# CARVER CORPORATION SERVICE BULLETIN

Service Bulletin # C-19-1

Model: C-19

REASON: To prevent fuse from blowing when turning on.

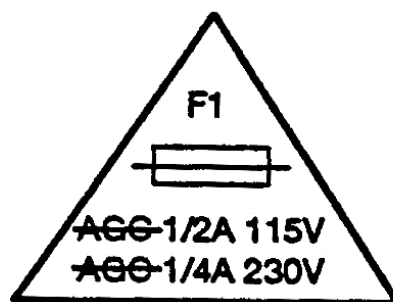
## DELETE

For 120V version:

Qty 1 Fuse, AGC 1/2  
P/N 315-10504-00

For 230V version:

Qty 1 Fuse, AGC 1/4  
P/N 315-10503-00

C-19 preamplifiers manufactured before serial number 000822 contain fast-blow fuses, which have been found to occasionally blow from the turn-on surge when the unit is switched on.

## ADD

For 120V version:

Qty 1 Fuse, MDL 1/2  
P/N 315-12012-00

For 230V version:

Qty 1 Fuse, MDL 1/4  
P/N 315-12011-00

If the C-19 has a serial number below 000822, or if the fuse blows for no apparent reason, verify that it has a slow-blow (MDL) fuse.

1. Turn unit off and unplug from outlet.
2. Remove top cover by removing 8 screws.
3. Locate fuse in fuse clip on PCB.
4. Remove fuse from fuse clip and verify that it is an MDL-type.
5. If not, replace with an MDL 1/2A fuse for 120V units, or an MDL 1/4A fuse for 230V units.
6. Use an indelible marker to blacken out the letters "AGC" on the PCB screening near the fuse.
7. Replace top cover.
